Re: Product change notification for Harwin product.

There has been a change to the tape pocket and cover tape design on the following product (links to Drawings are also given):

- S7151-45R

Title:
SMT Spring Contact (3.00mm High) in Tape and Reel
Drawing number:
S7151-45R

Tape Details

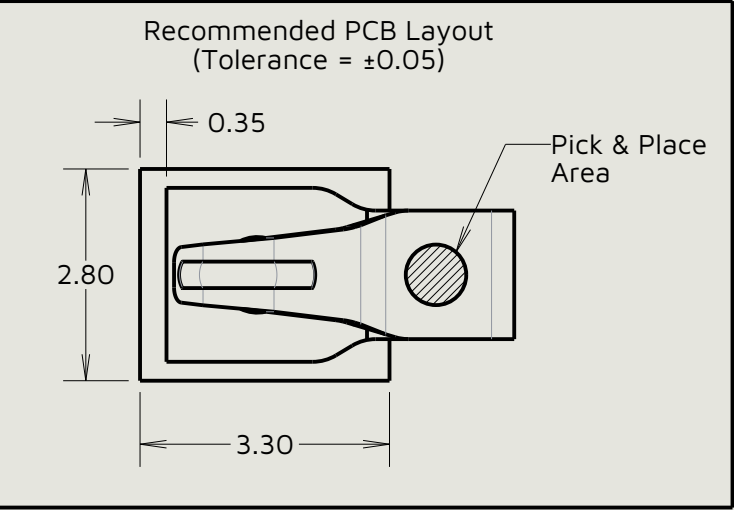
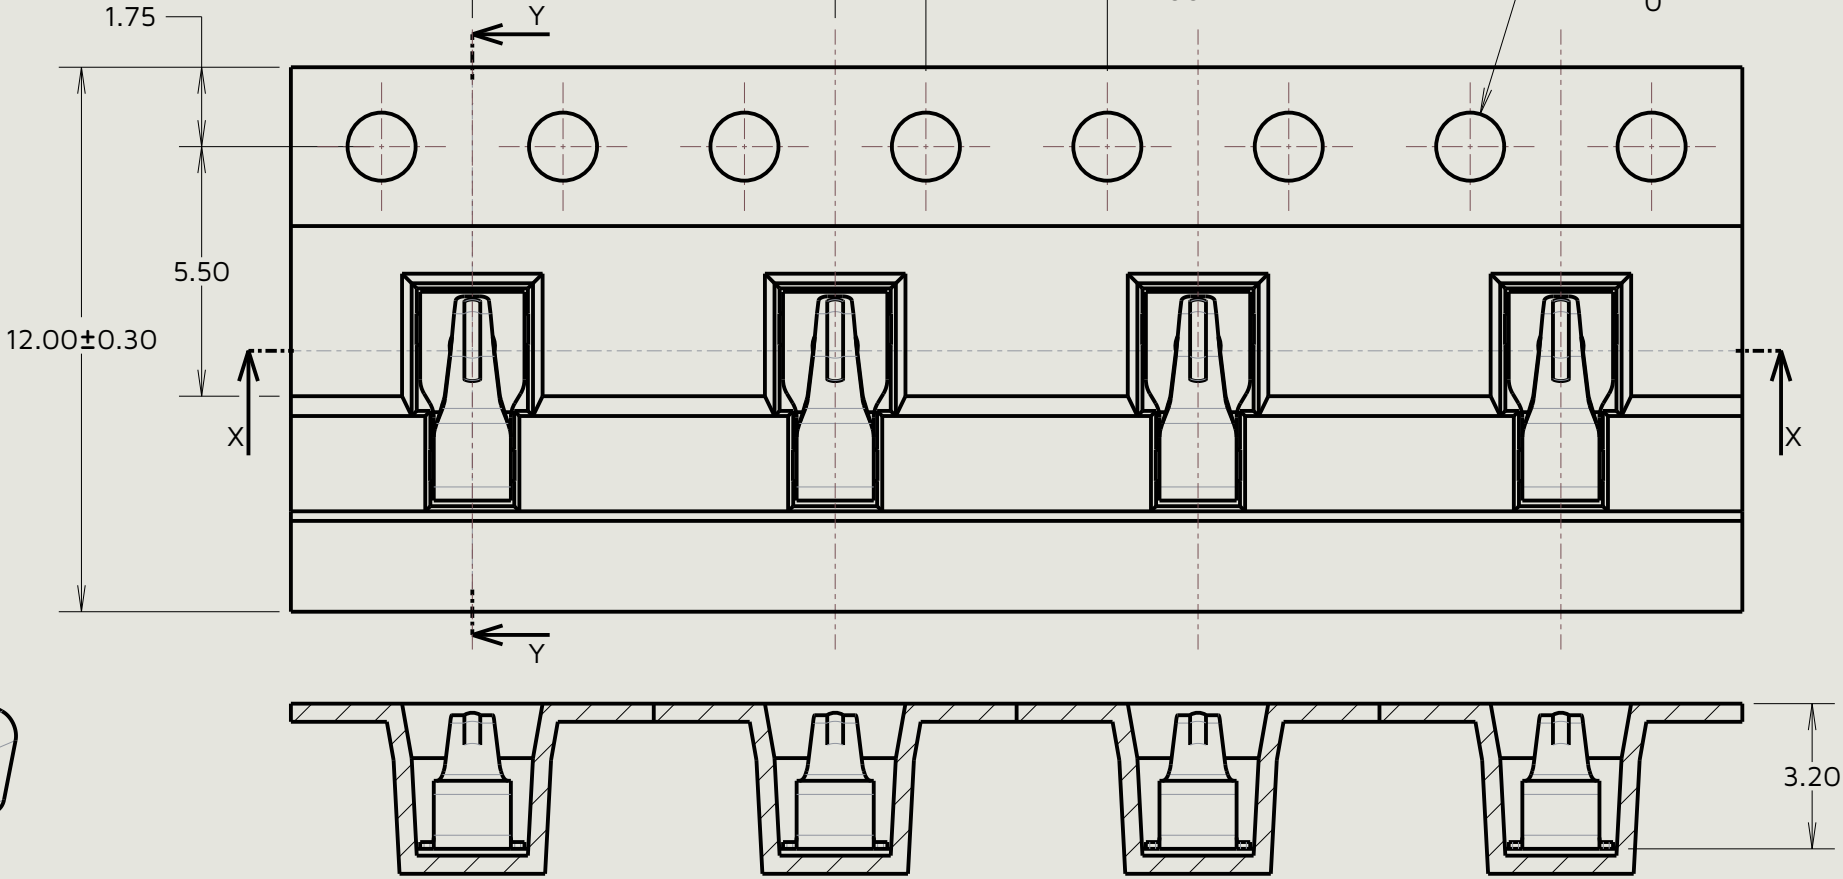
The tape pocket now has a channel running along the length of the tape, and the cover tape now dips down into this channel. This revised packaging method has been tested and continues to meet the EIA-481 requirements. The spring contact itself is not affected and remains unchanged.

This packaging improvement minimises the risk of these miniature low-profile contacts turning or twisting within the pocket.
